2x10 FRAMING INSULATION ASSEMBLY

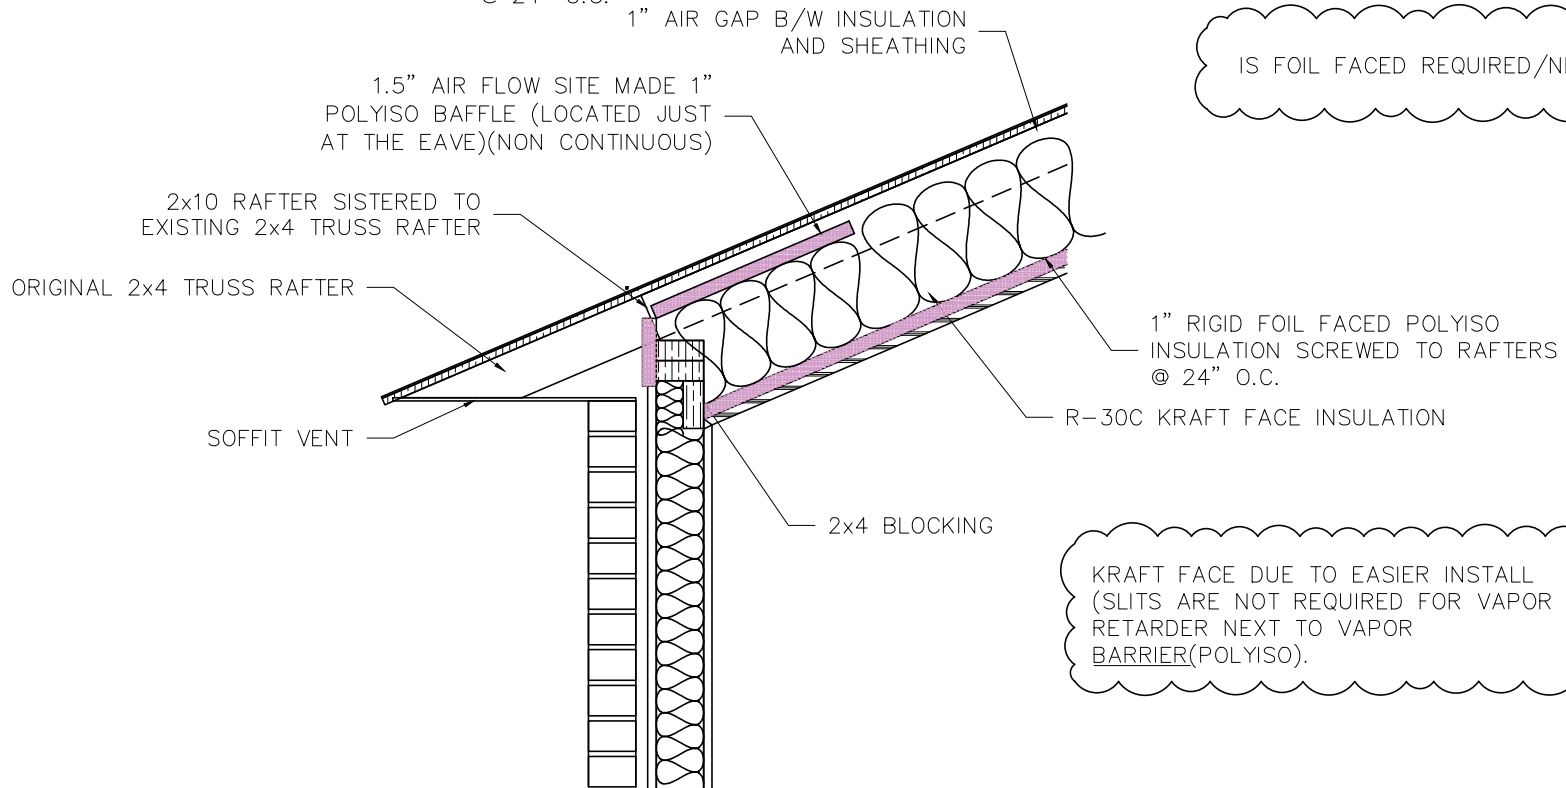
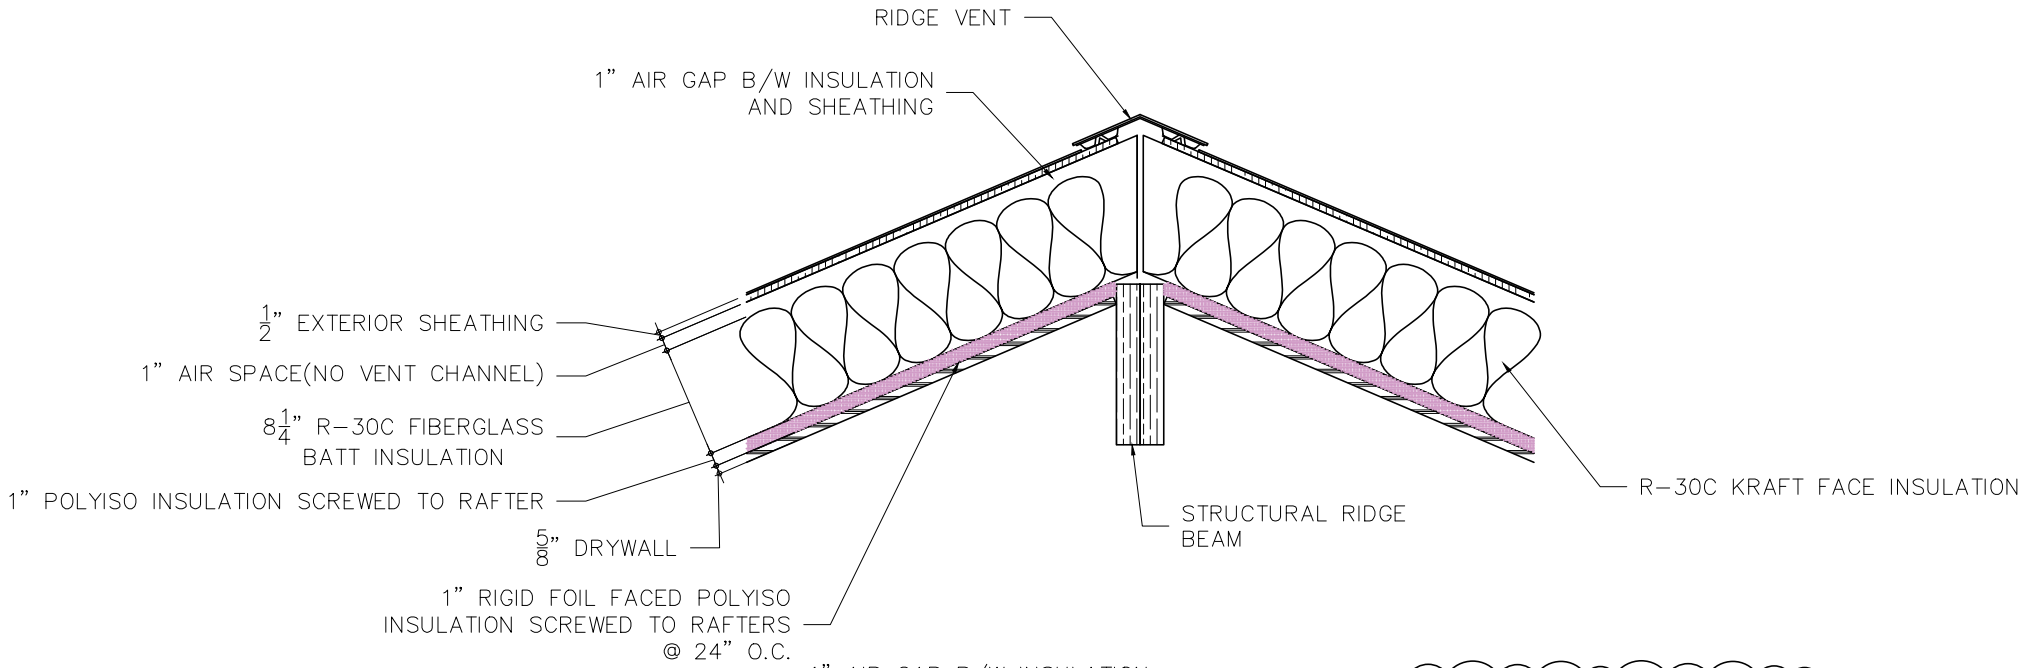
IS FOIL FACED REQUIRED/NEEDED?

KRAFT FACE DUE TO EASIER INSTALL (SLITS ARE NOT REQUIRED FOR VAPOR RETARDER NEXT TO VAPOR BARRIER (POLYISO)).
